PASCO COUNTY, FLORIDA
INTEROFFICE MEMORANDUM

DATE: 8/20/15 FILE: PDD15-1568

SUBJECT: Small Commercial
Development Review – Gulf
View Chipotle Preliminary Site
Plan/Construction
Plan/Stormwater Management
and Plan and Report and
Alternative Standard (Project
No. SML15-039)
Recommendation: Approval
with Conditions (Attachment
No. 1)

APPROVED PLANS
8/20/15
PDD15-1568/KS
SML15-039

GULF VIEW SQUARE CHIPOTLE
PASCO COUNTY, FLORIDA
LANDSCAPE PLAN

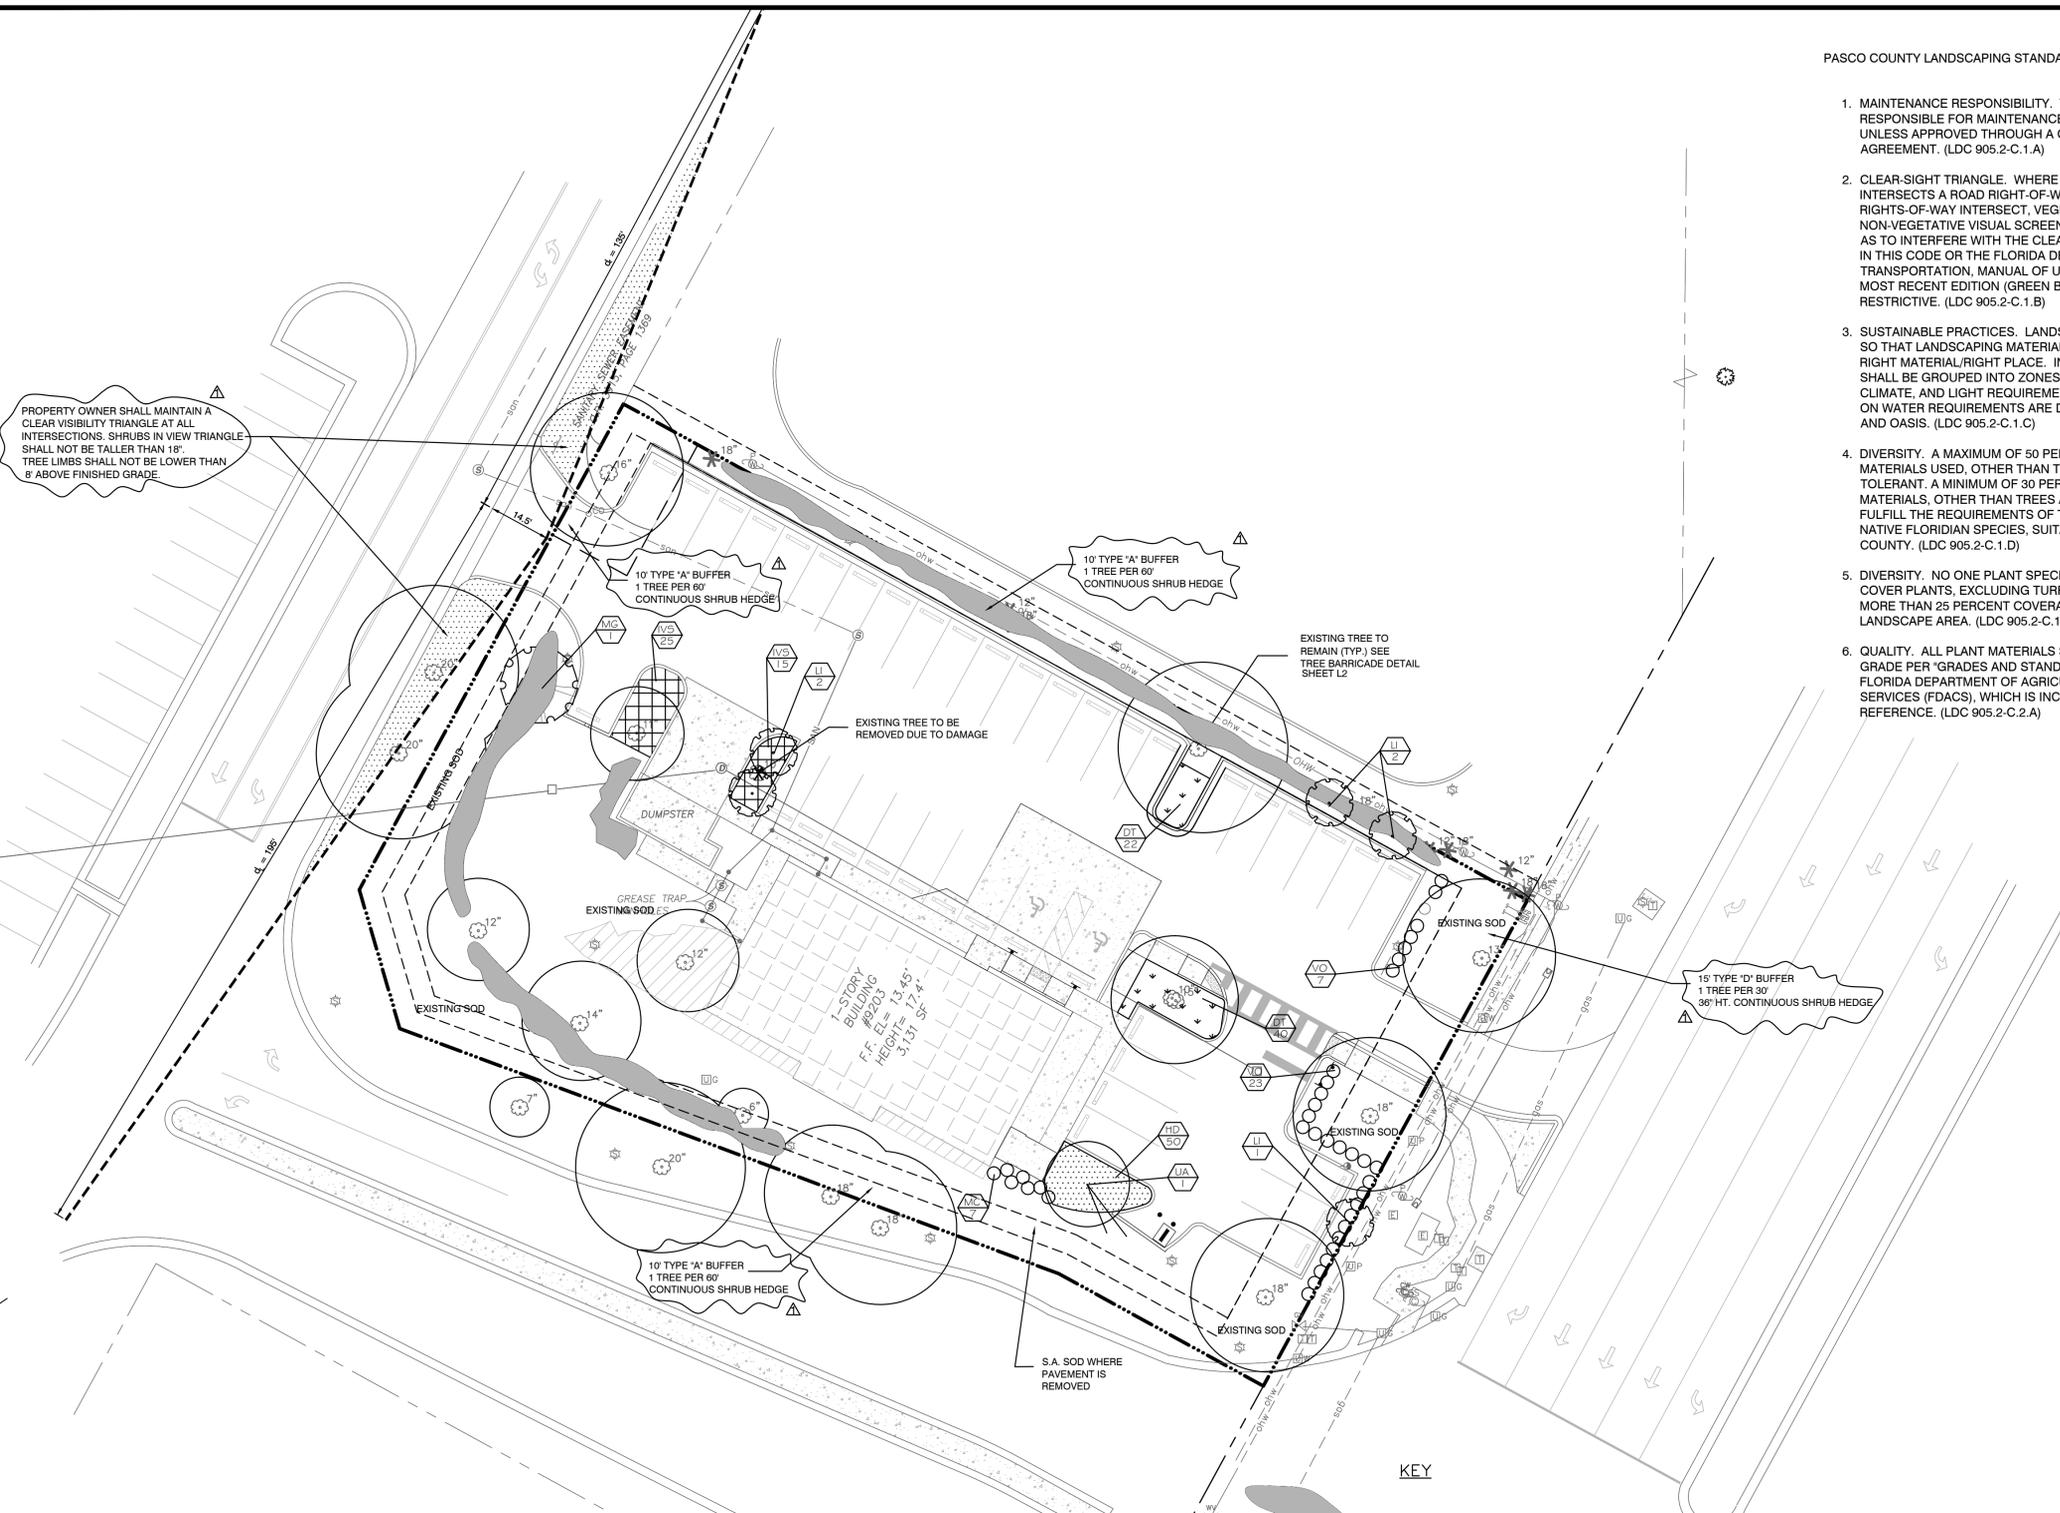
Subsection 905.2.E, Type D Buffer, which, if approved, would relieve the applicant/developer of providing the required buffer of 15' and 18" high earthen berm.

"The existing/proposed front buffer yard is greater than 15' deep (25'+ to back of curb), with the exception of where the 3 existing parking stalls encroach. As depicted and enumerated on the alternative standards site plan, the buffer area provided exceeds the equivalent area required by a uniform 15' buffer width. Plus, retaining existing conditions allows for preservation of 3 existing canopy trees (13", 18" & 18" Oaks), whereas these trees might not survive if 18" of fill were to be placed on top of their established root structure to create an earthen berm."

"The 3 parking spaces and 3 Oak trees could be removed but this would result in loss of parking and would require installation of new landscape plantings; whereas, retaining the established canopy trees provides better shading and visual impact."

Staff has reviewed the applicant's request and recommends approval of allowing an average in buffer and not providing an 18" earthen berm, in order to protect existing trees, provided that the new bushes that are proposed on site are 36" in height at time of installation.

27. The applicant/developer acknowledges that the proposed shrubs, along US Highway 19 shall be planted at a minimum height of 36" inches at time of installation.
